TOWN OF BAY HARBOR ISLANDS PLANNING AND ZONING BOARD

April 17, 2018

Subject: Site Development Plan Application – Revision #1
Atlantis of Bay Harbor – 28 DU Multi-Family Residential Complex
10281 West Bay Harbor Drive
Bay Harbor Islands Acct. No. MB2017-21
MMPA Acct. No. 01-0702-1049

Below are all of the changes since the PZ Board approved the plans on March 21st, 2017:

DRAWING TITLE
LEVEL 7 FLOOR PLAN
SCALE: - DATE: APRIL 3, 2018
SHEET NUMBER
A-107
P&Z REVISIONS

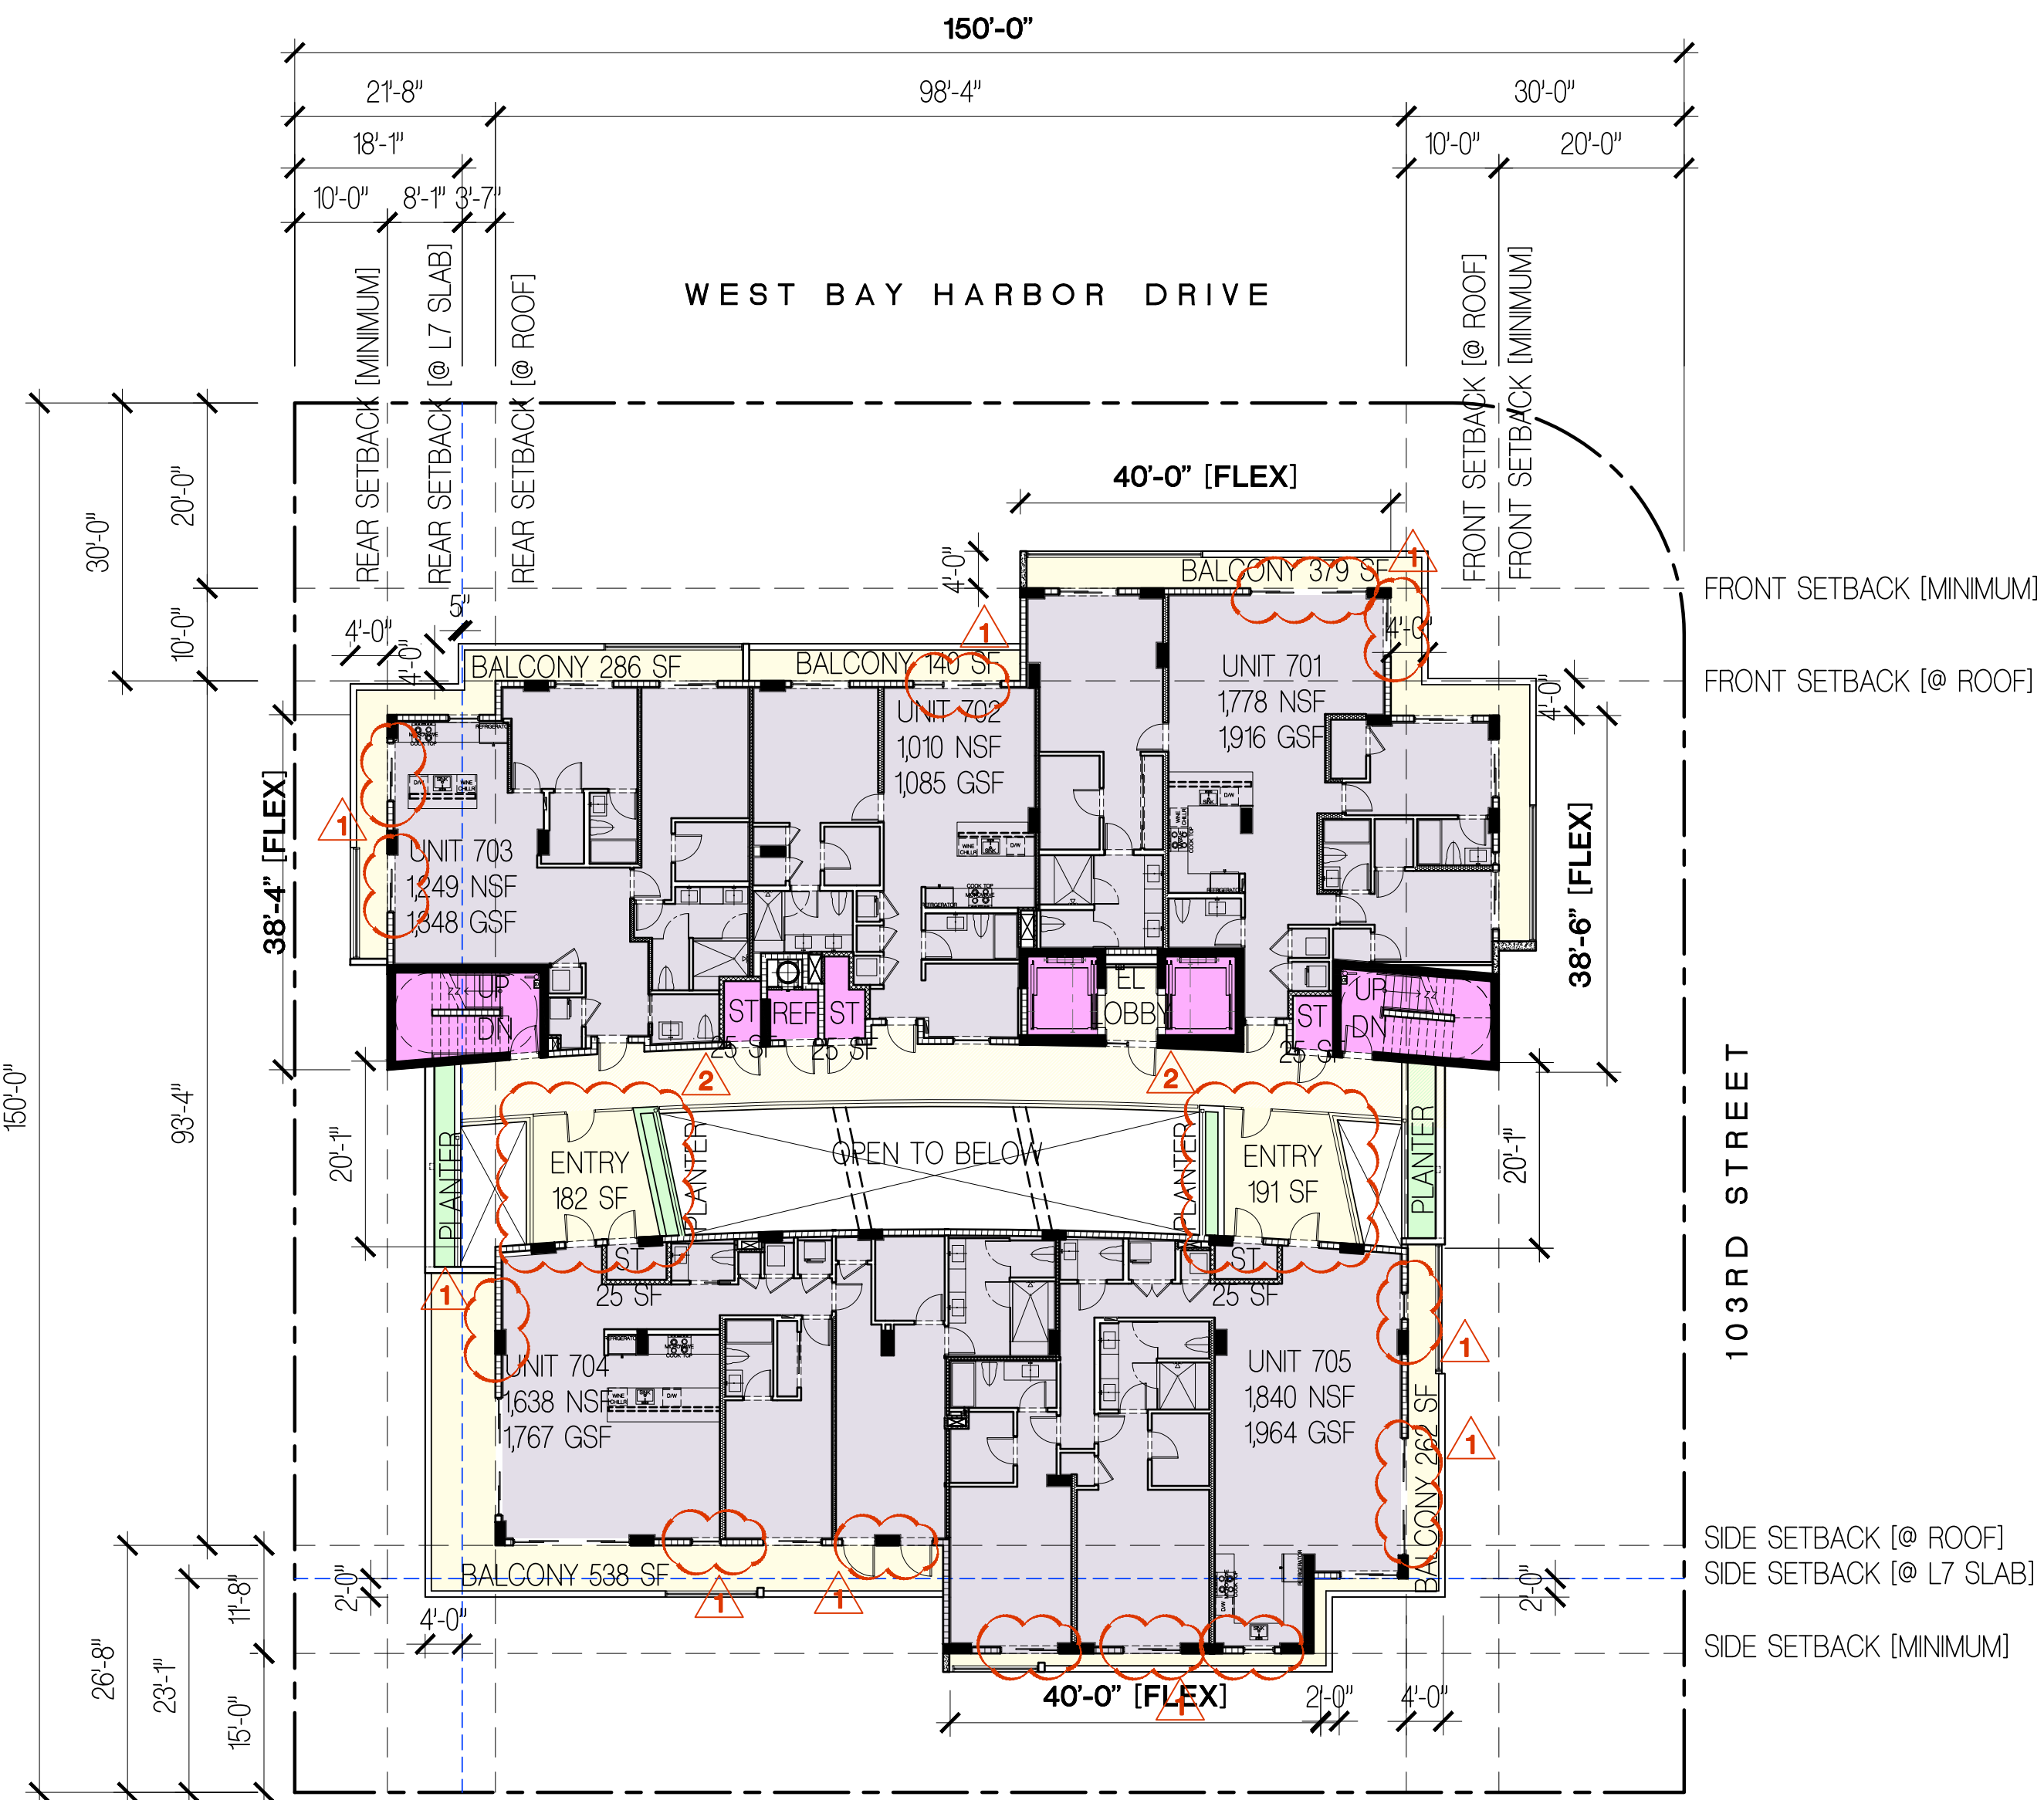
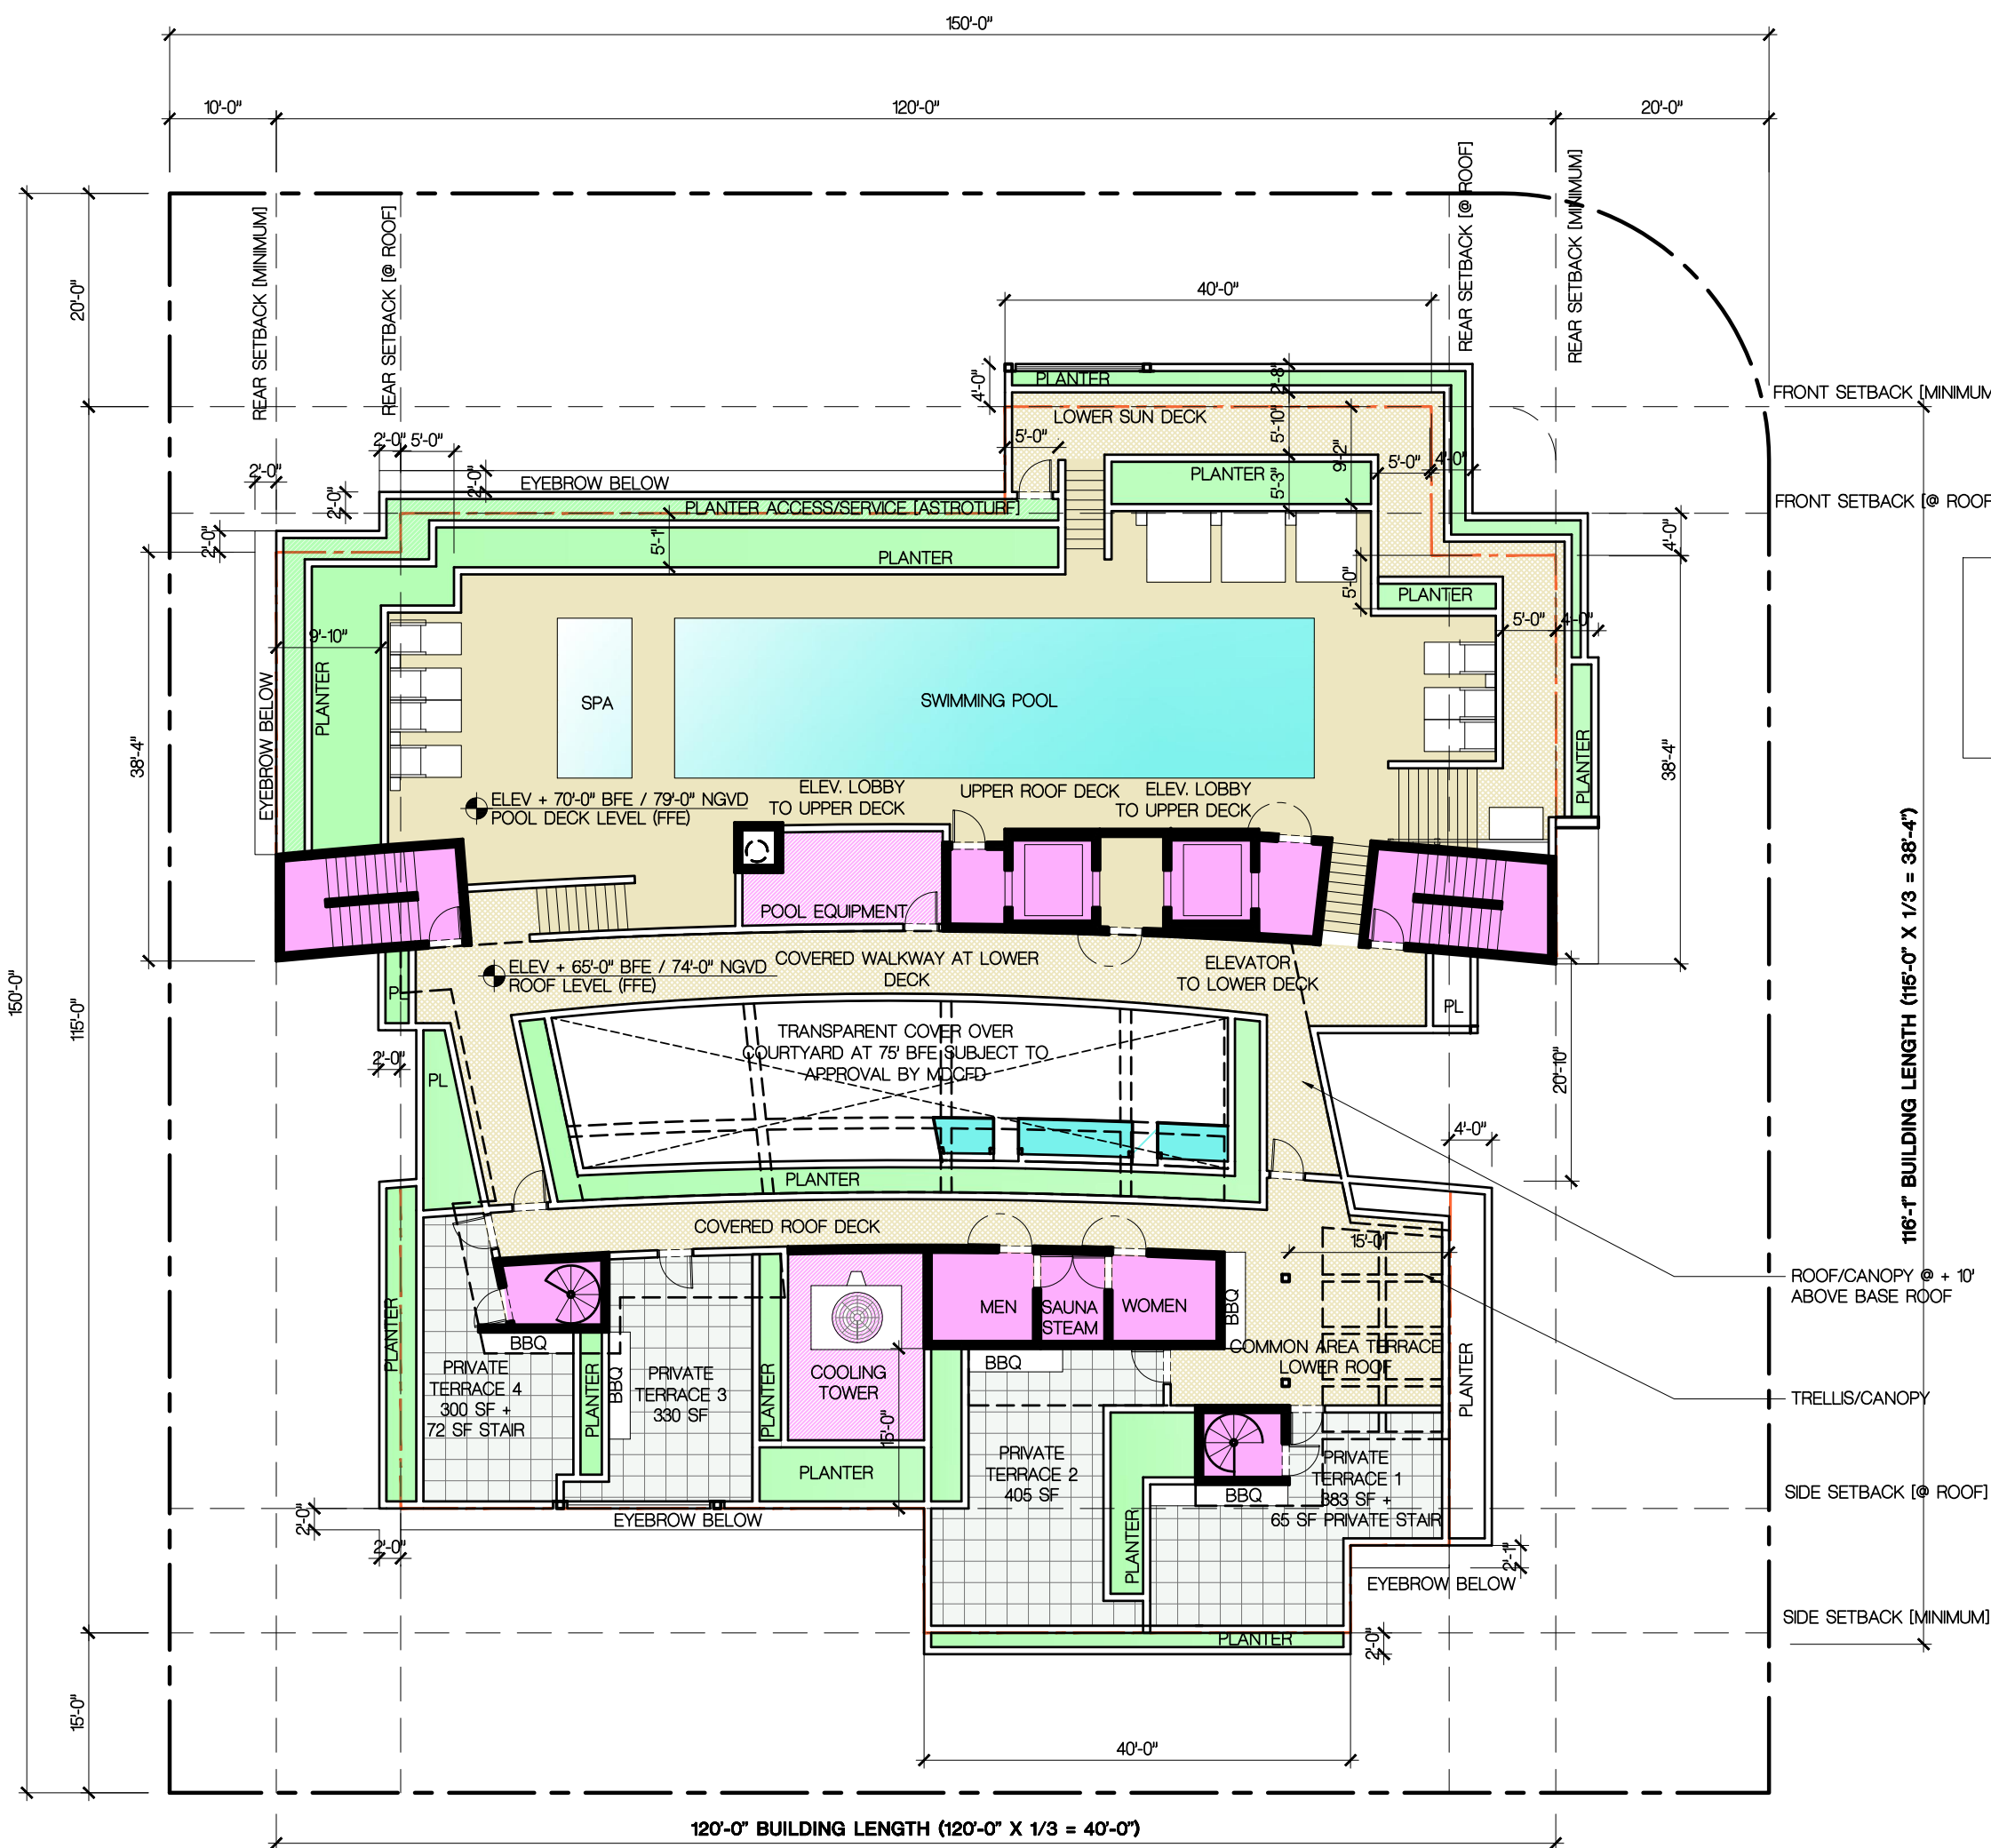
- 1 REDUCED GLAZING ALONG THE EXTERIOR PERIMETER
- 2 INCREASED THE AREA OF THE 3 PRIVATE ENTRY COURTS TO THE NORTH UNITS.
